# City of Southaven Office of Planning and Development Design Review Staff Report

Date of Hearing:	April 24, 2023
Public Hearing Body:	Planning Commission
Applicant:	Pediatric Dental Group & Orthodontics c/o Patrick Haralson 1365 S Germantown Road Germantown, TN 38138
Total Acreage:	1.54 acres
Existing Zone:	Planned Unit Development (Silo Square)
Location of Design Review Application	West of Market Square Avenue, north of Front Street
Comprehensive Plan Designation:	Office

# Design Review Documents for the Southaven, Mississippi Planning Commission

# PDGO Pediatric Dental Group Silo Square, Lot 36 Southaven MS

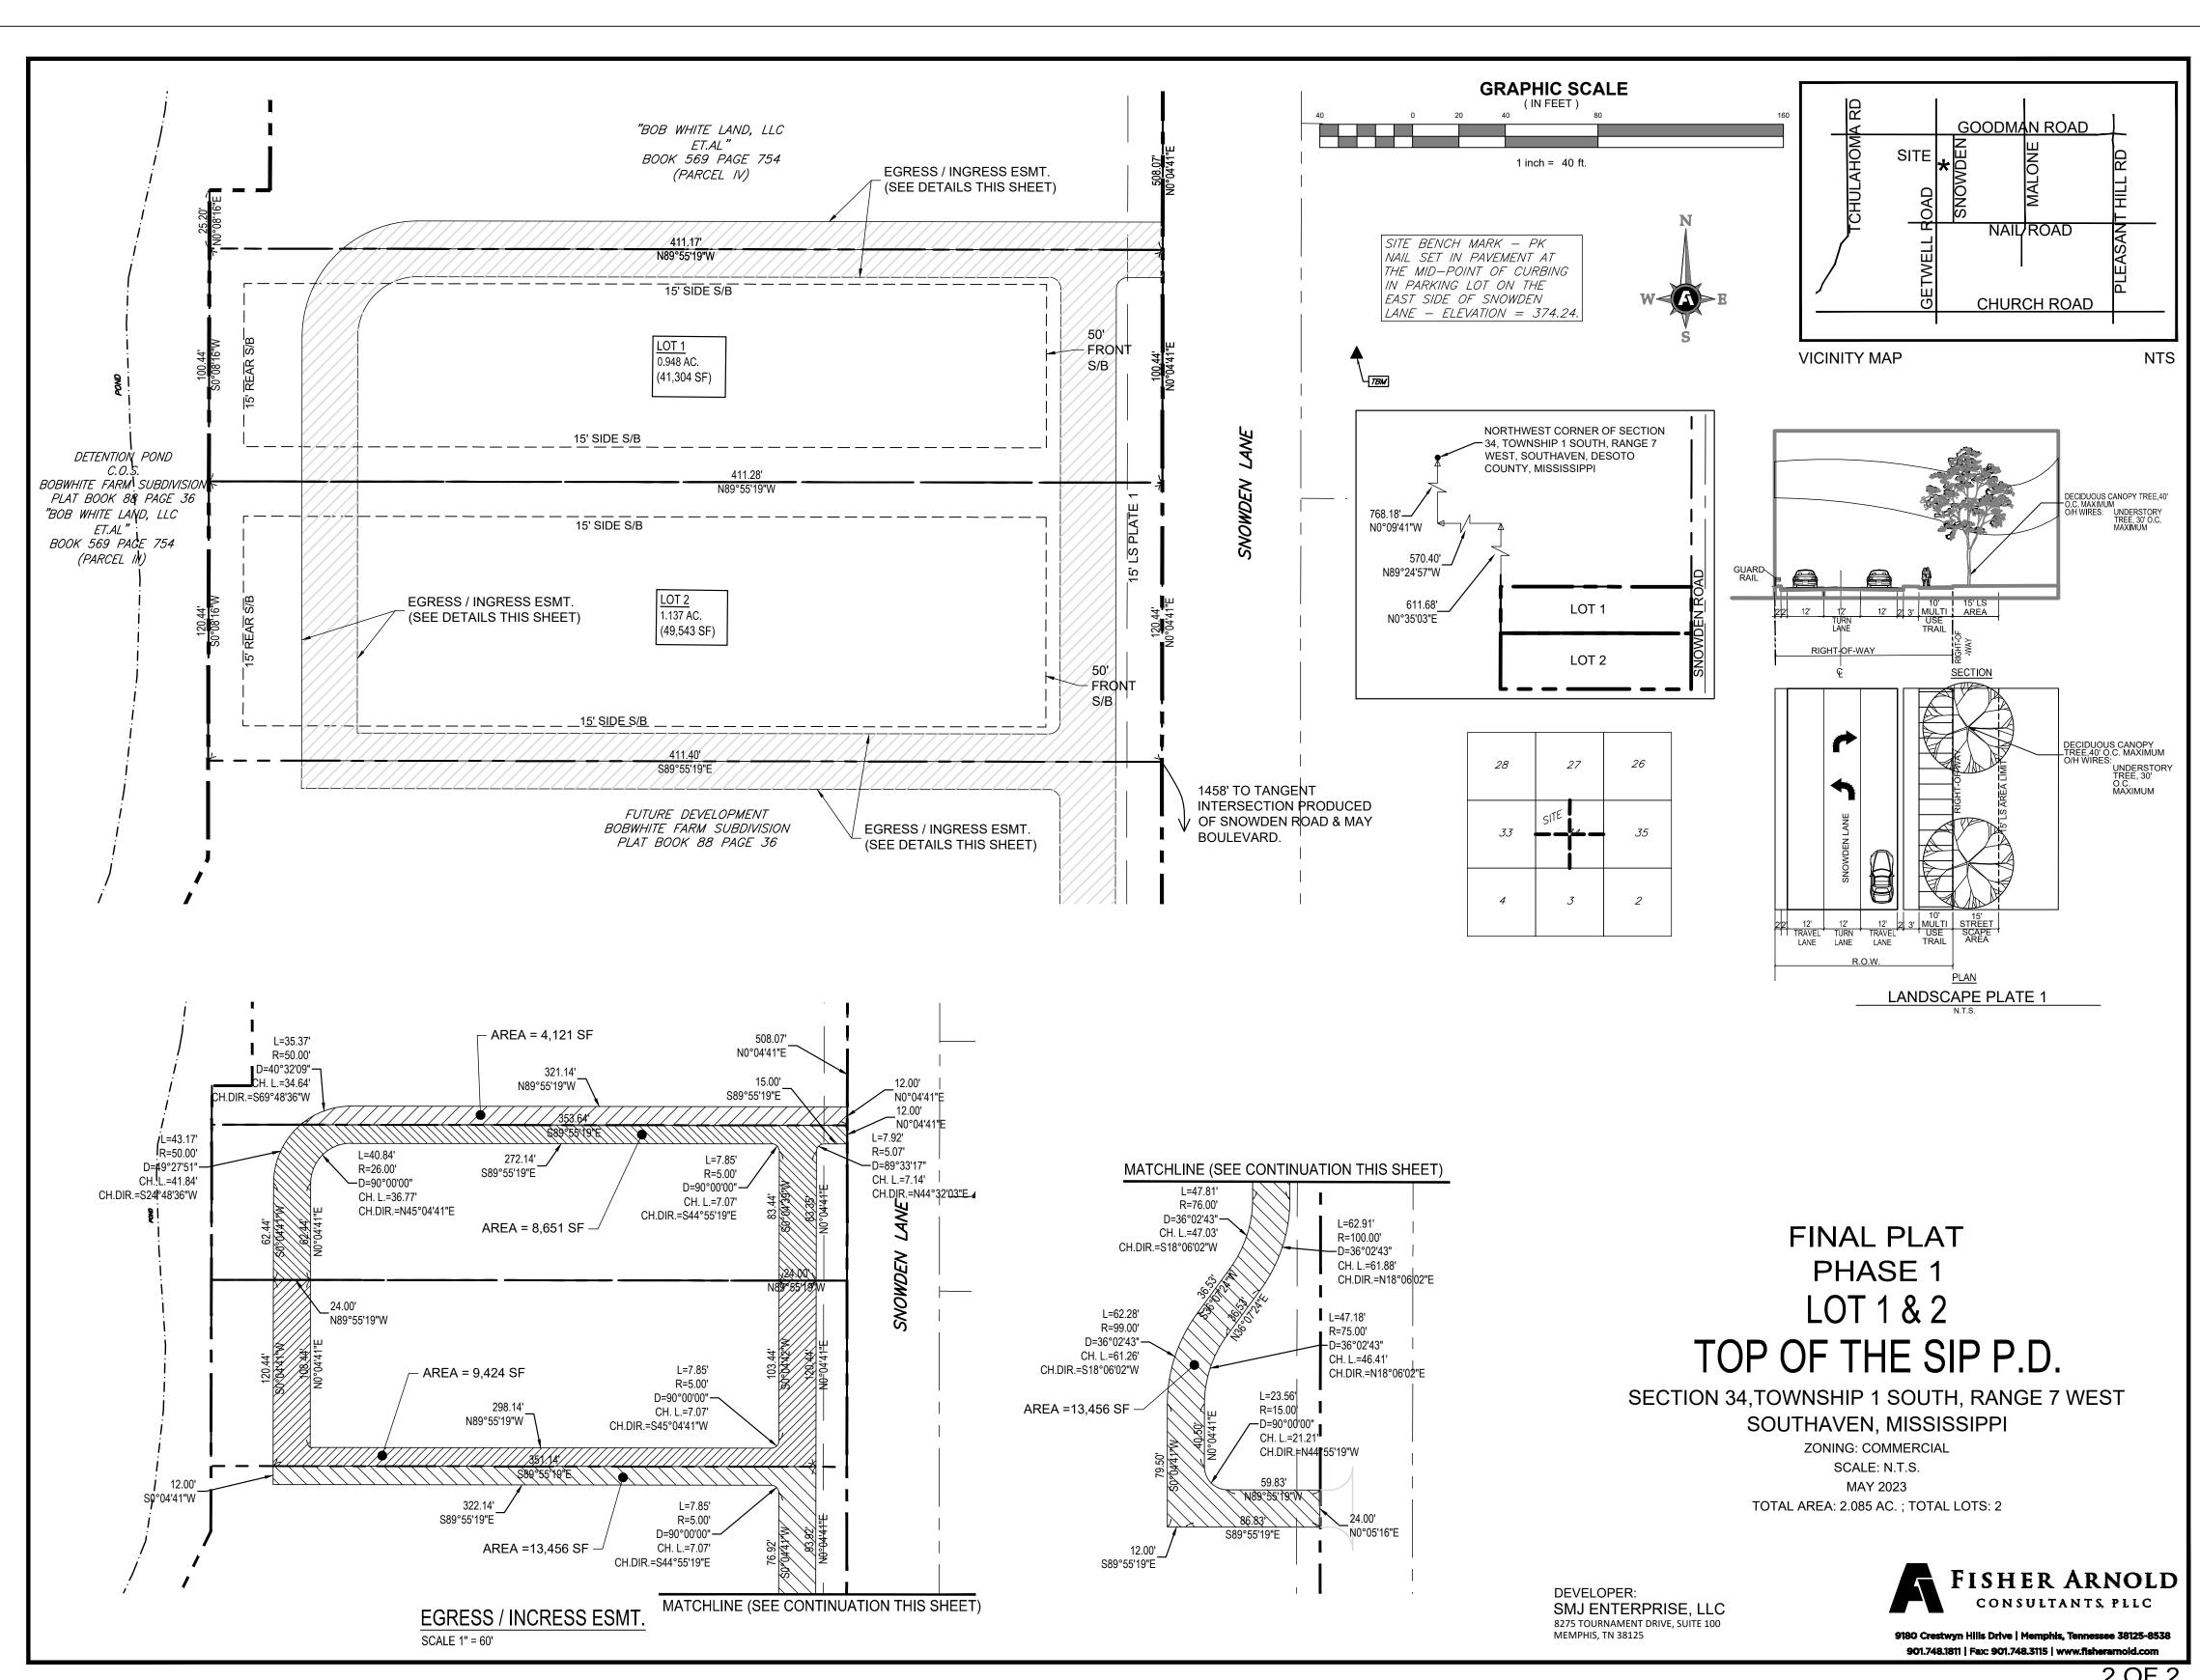
The proposed plat is compliant with the requirements set forth in the ordinance regarding commercial subdivisions. Staffs only question would be the build out of the ingress/egress which are shown partially on future development sites. Will these roads be built to their full width with this project? There have been situations where developments only build out the 50% on their lots and sometimes that is acceptable to staff; however, this site needs to adjust for the entire width so that proper two way accessibility is achievable.

LANDSCAPE PLAN

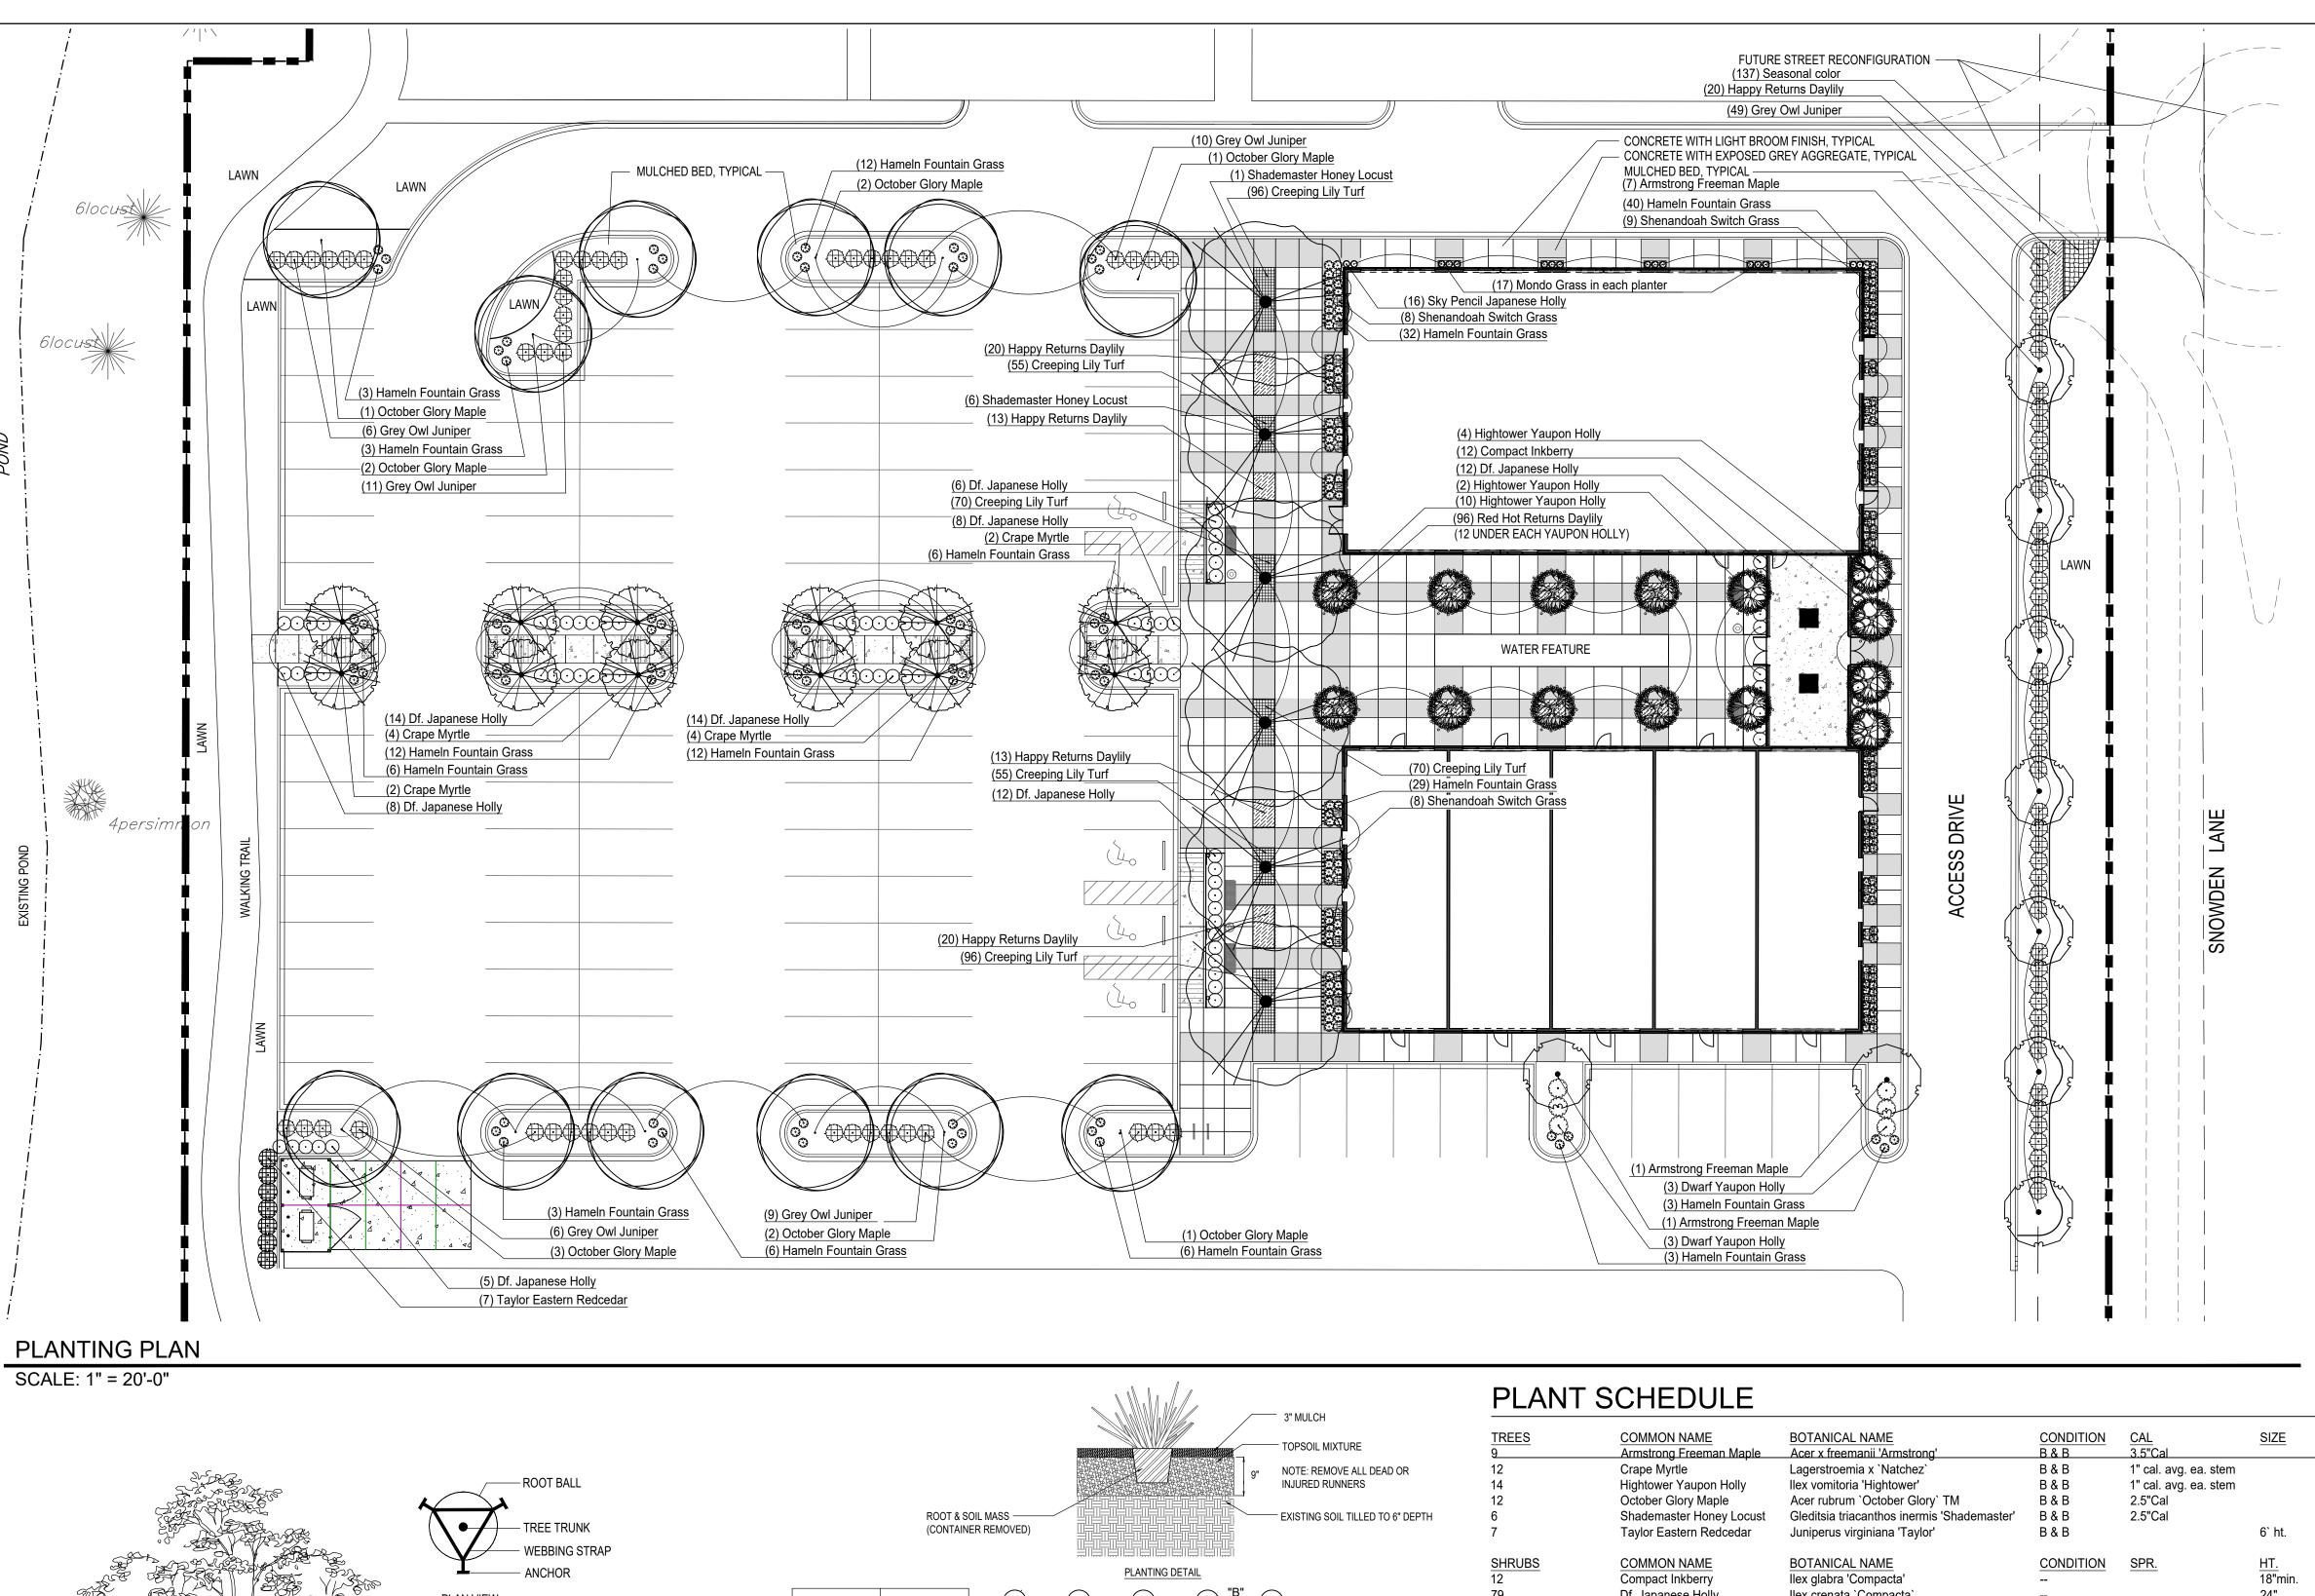
Staff has several concerns with the landscape plan and has redlined the submittal plans to show the requested revisions. In summary, staff would like to see the materials revised to show less crape myrtle and more evergreen materials. Staff would also like to see the crape myrtles in the courtyard area changed out to Yoshino cherry which would reduce the amount of shedding to an early Spring season only and would also alternate bloom times against the crape myrtles giving a longer flowering season to the site. The crape myrtles proposed along the screening wall areas should be changed out to an evergreen material so that year round screening is achieved. Staff would like to see a much more in depth streetscape design for Snowden Lane. Although these buildings are oriented away from Snowden Lane, it is still the most visible line for the vehicular site. Staff would suggest a planting bed on both sides of the ingress/egress areas, and an alternating line of materials to include a single maple tree and a cluster of three crape myrtles. An additional meandering line of shrubbery mixture should be placed in between the tree plantings or as a backdrop. The north side of the north building will also be up against the main access drive so it concerns staff that a driver's first view will be the back of a building and a sidewalk. It would be staff's recommendation to carry the planter boxes with the fountain grass along this elevation to give a faux front appearance. The dumpster enclosure is required to have a tight line of screening on three sides which the applicant needs to incorporate into the design. The overall sizing needs to be addressed the meet the minimum requirements set forth in the ordinance.

Staff has submitted the redline copy of the landscape plan to the applicant to make the proper adjustments. Staff has no further comments and recommends approval.
